2AM-MEL1631 Water Licence Amendment

Information Request Responses

Submitted to:
Nunavut Water Board

Submitted by:
Agnico Eagle Mines Limited – Meliadine Division

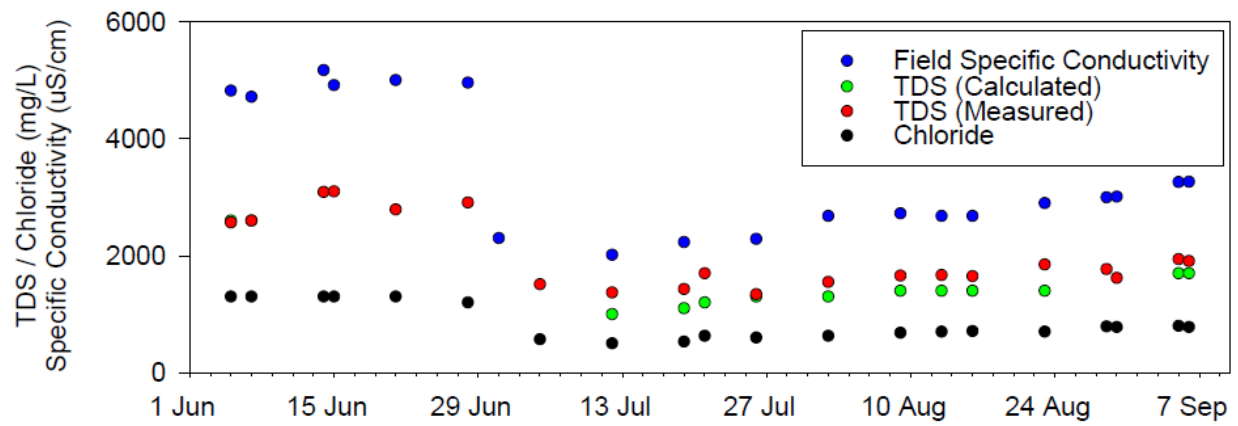
ECCC requests that the Proponent clarify the need for a discharge limit for TDS of 3500 mg/L, given the predicted concentrations.

As detailed in the response to CIRNAC-2, the maximum average concentration discharge threshold for TDS of 3,500 mg/L was determined to be protective for the receiving environment of Meliadine Lake based on three criteria outlined in the WQ-MOP Rev3:

As discussed, the monitoring is highlighted in the figure below that highlights the 2020 TDS measurement in CP1. This is an example of the peaks observed during the discharge season and why the 3500 mg/L TDS discharge threshold remains protective and allows the flexibility for the operation.

Figure 3-1 Relationship between chloride and calculated TDS, and chloride and measured TDS, in discharge from CP1 (End of Pipe) and in Meliadine Lake (Receiving Environment) during the 2020 discharge period.

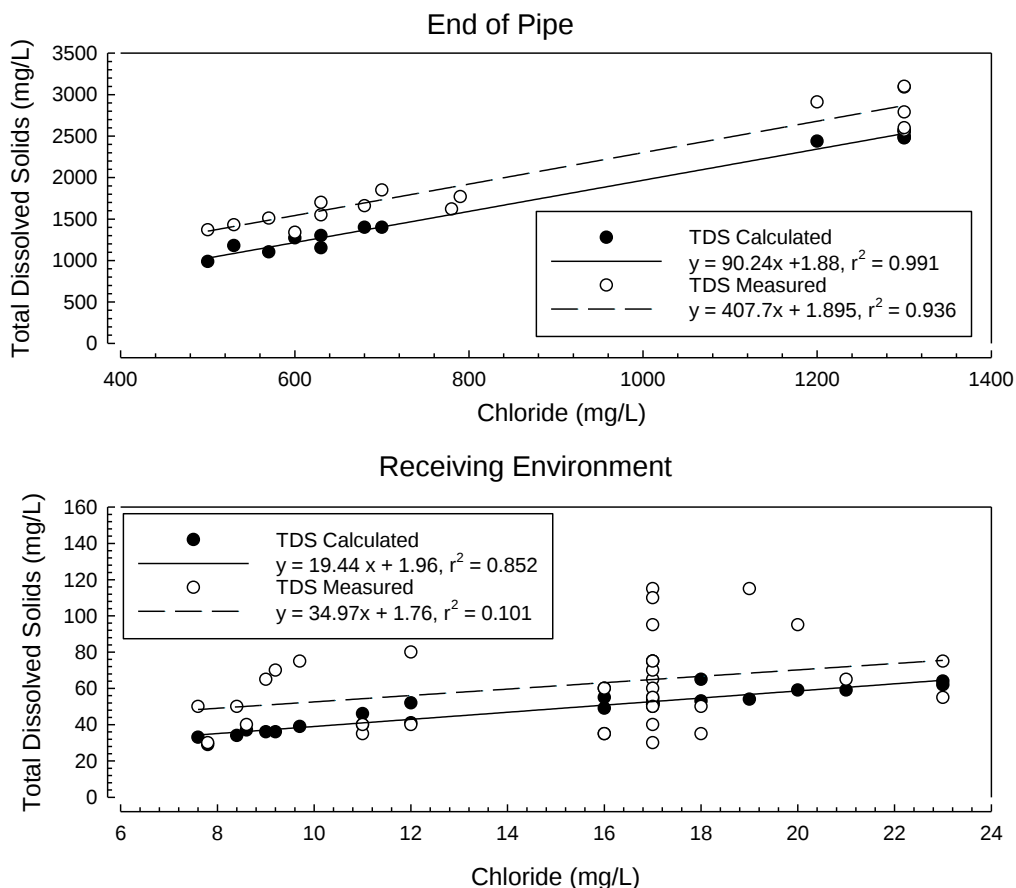
Please clarify whether Agnico Eagle will be relying on measured TDS, calculated TDS, or a combination of the two when evaluating compliance with the discharge criteria and determining when to implement adaptive management strategies. Please include a comparison between the accuracy of calculated vs measured values.

It is Agnico Eagle's preference to use calculated TDS to evaluate compliance with thresholds for discharge and at the edge of a mixing zone, and in decision-making with respect to adaptive management. Calculated TDS concentrations account for the contribution of major cations (e.g., sodium, potassium, calcium, and magnesium) and anions (e.g., bicarbonate, chloride, and sulfate), which account for the majority of the TDS in natural waters, groundwater, and Mine water associated with this application, and other specific ions (e.g., fluoride, silica, and nitrate), which also feature as natural and contributing TDS components in these water sources. The derivation of calculated TDS concentrations is from the sum of the analytical results for each of the contributing ions from a water sample using the formula in Standard Methods (Method 1030E, APHA 2012; Eqn 1). The analytical resolution associated with the laboratory analysis of each of the contributing ions results in a very accurate and reliable estimate of TDS.

Figure 3-1 show summary data that supports Agnico Eagle's position. The box and whisker plot shows a more consistent relationship between chloride with calculated TDS concentrations compared to

measured TDS concentrations in discharge from CP1 and Meliadine Lake (i.e., the edge of mixing zone, mid-field, and reference locations; the receiving environment) from data collected during the Emergency Amendment to Meliadine Lake (June to August 2020).

Using calculated TDS concentrations means that changes in the amount of TDS in waters associated with Meliadine Mine will be detected with more certainty than if measured TDS concentrations are used. Therefore, the use of calculated TDS concentrations is expected to provide more consistent and reliable results when tracking temporal and spatial trends and assessing conformity to thresholds.

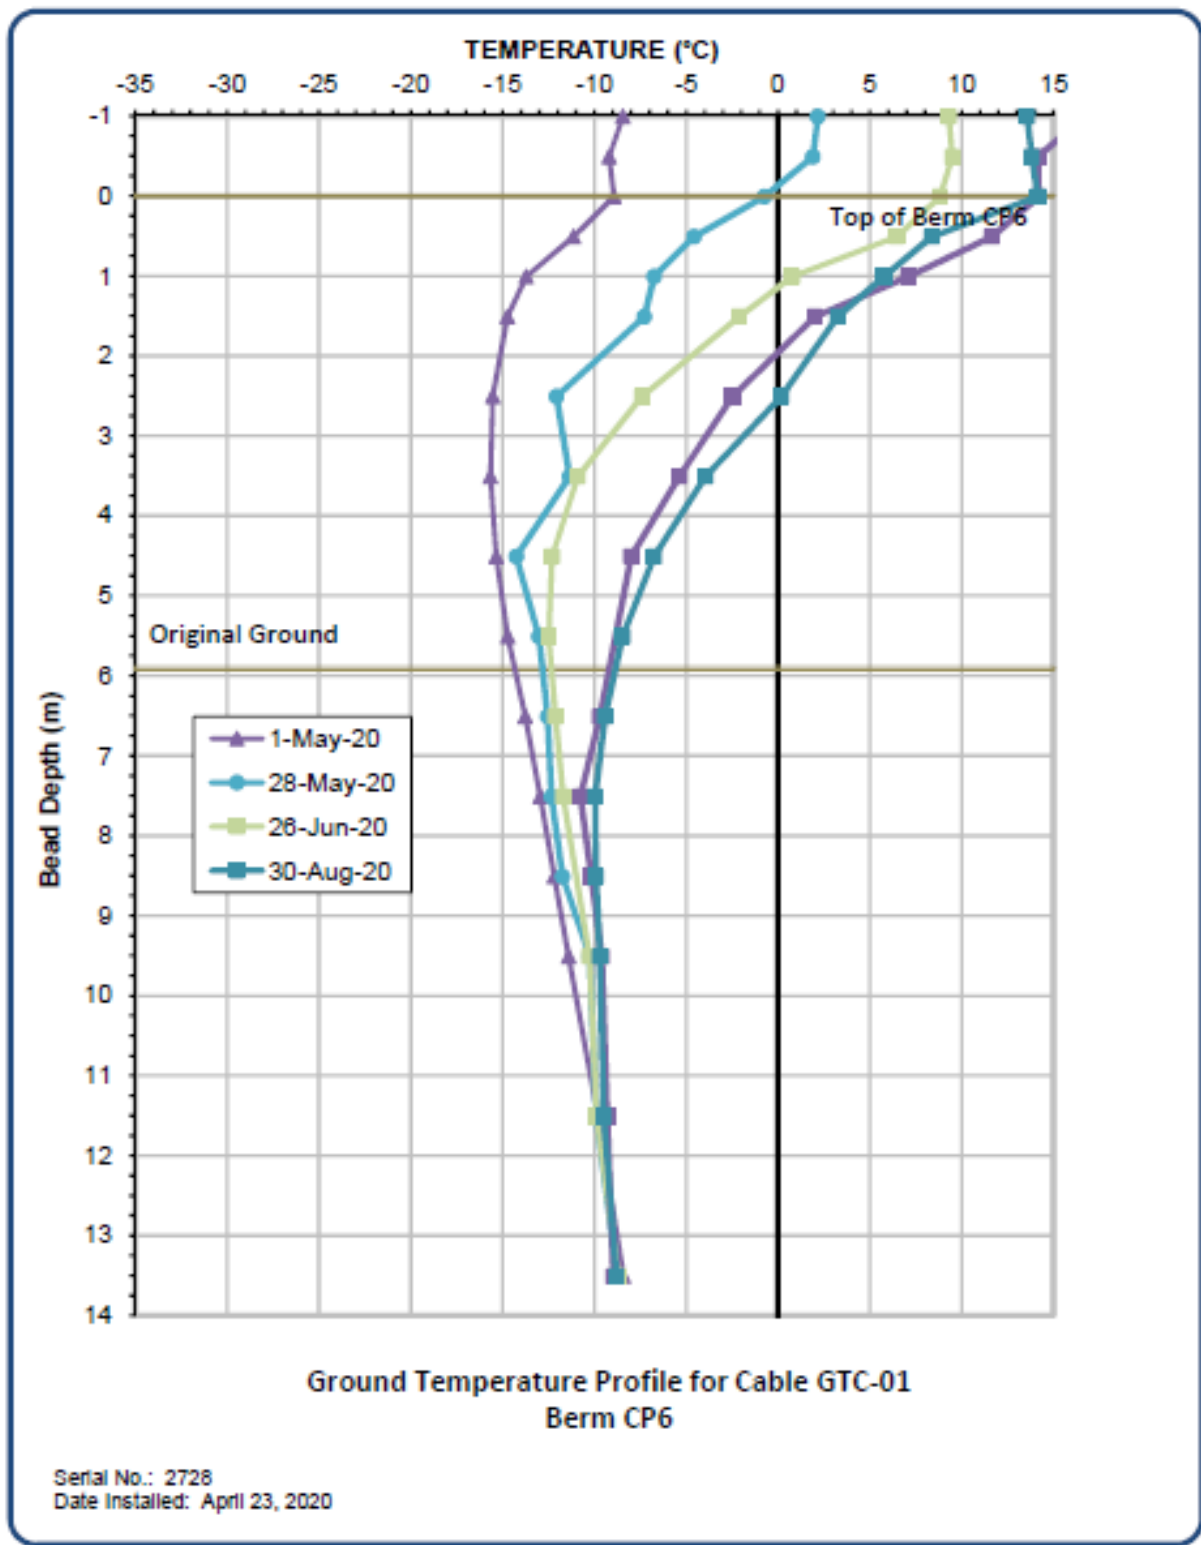
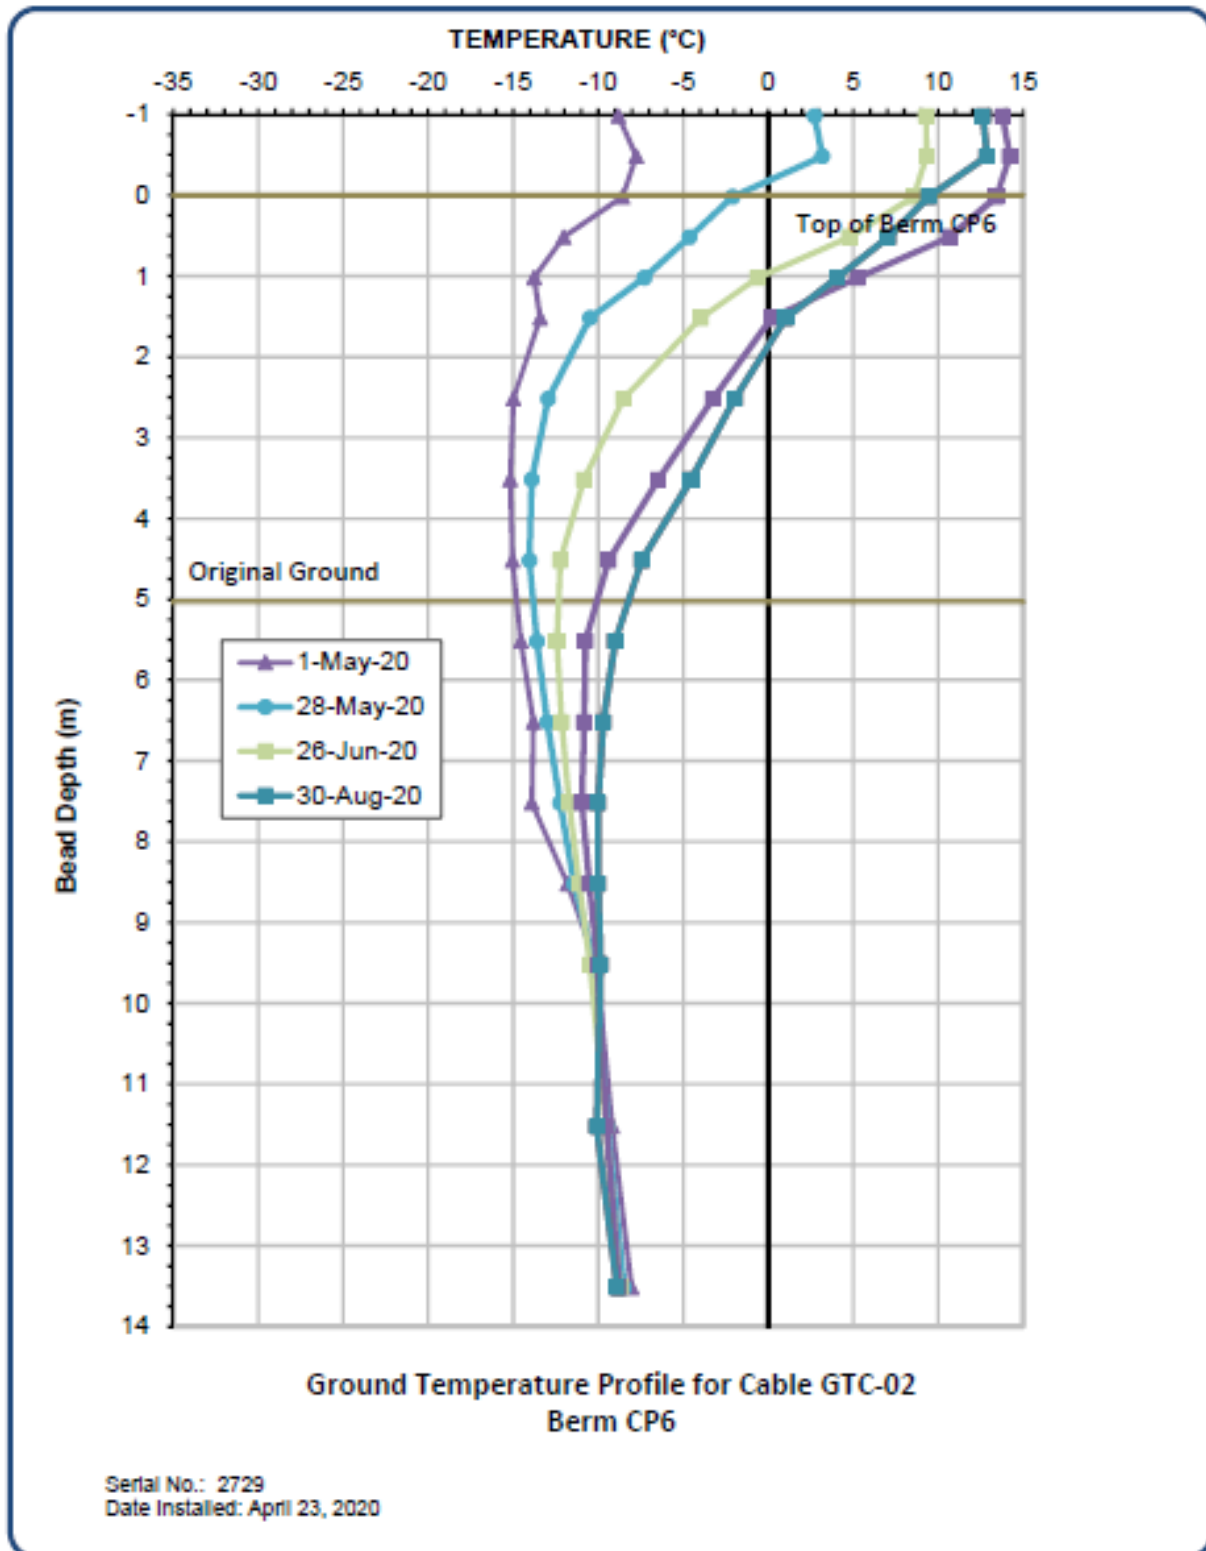
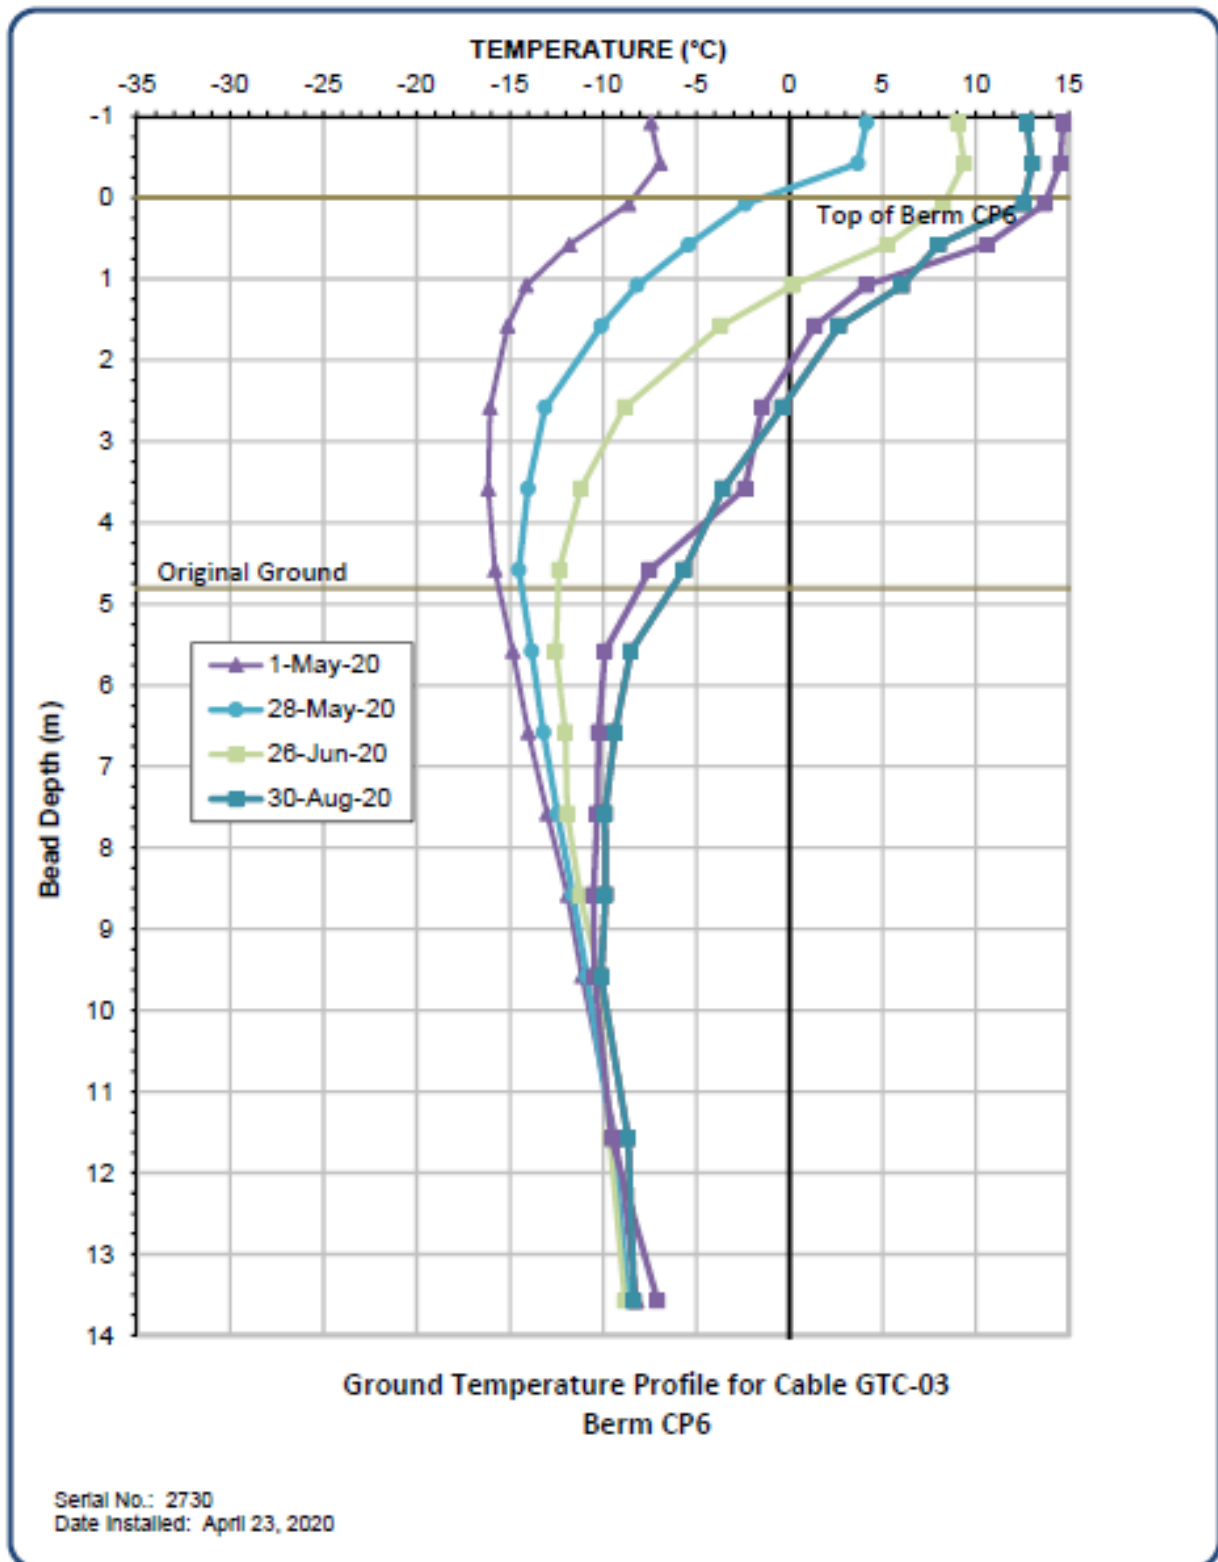
The KIA requests that the proponent provide the current thermal data available for the area downslope of WRSF 3, Berm CP-2 and Berm CP-6 to the edge of Meliadine Lake.

Agnico Eagle would like to clarify that talik conditions surrounding Lake B7, as well as under former Lakes H19 and H20 were suspected preceding the detailed design of CP3, CP4 and CP6. As such, single bead thermistors were installed during the geotechnical drilling campaigns in order to guide their detailed design.

The figures below present the thermistor data located in the downstream slope of Berm CP-6. It should be note the thermistors haven't been in place for a full year, however to date the berm appears to be fulfilling its function and the underlying ground has remained frozen.
